4-STROKE
BULLETIN GS/GSX/GSX-R NO. 126
DATE: 12/10/2002

SUBJECT: STARTER SYSTEM PARTS INTERCHANGE INFORMATION

MODEL: GSX1300R Hayabusa
1999 through 2002 (X ~ K2) MODELS

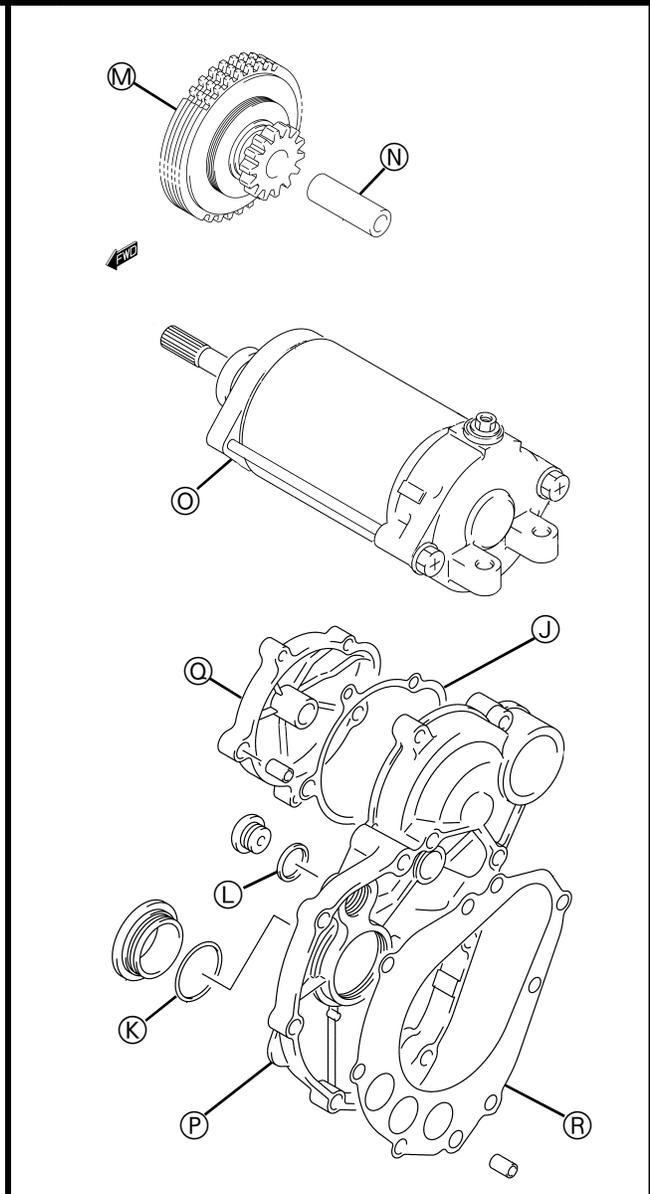
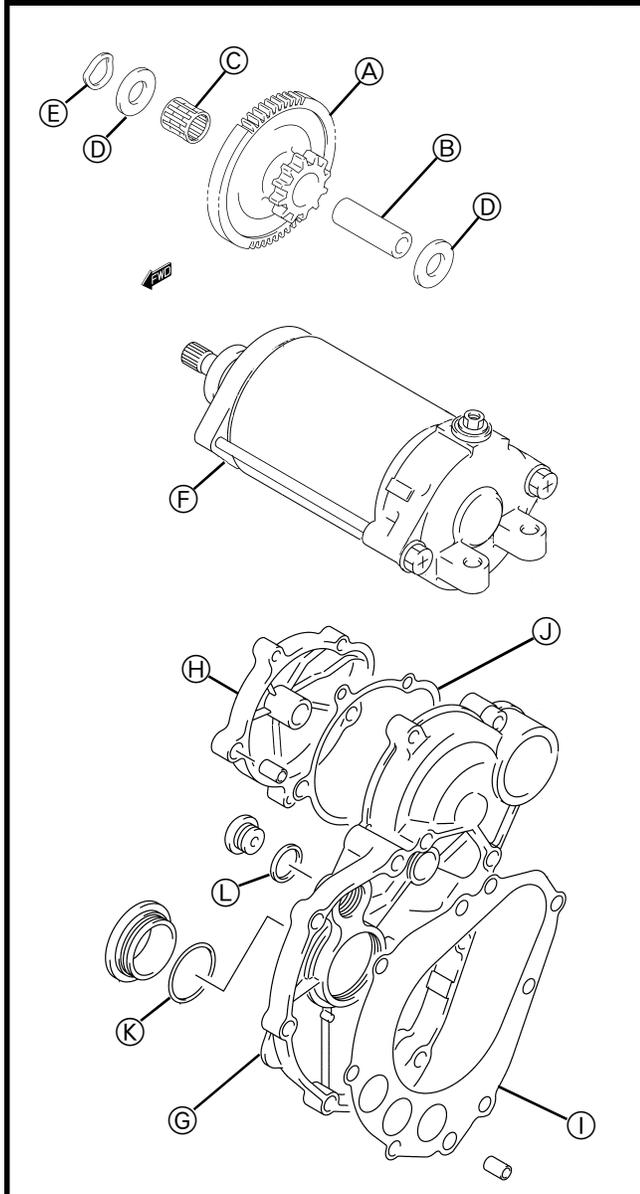
The starter system parts of the 2003 GSX1300RK3 have been changed as compared to earlier Hayabusa motorcycles. The system now incorporates a starter idle gear limiter, similar to the type used on a DR-Z400E.

These new parts can be installed in place of the original parts if you need to repair the starter system of a 2002 or earlier model Hayabusa. Please follow the recommendations in this bulletin if you decide to place the new, K3-style starter system parts into an earlier model GSX1300R.

When installing the new starter torque limiter, use the new pin (12615-24F00). DO NOT reuse the pin, wave washer, washers or bearing from the original starter idle gear No. 1.
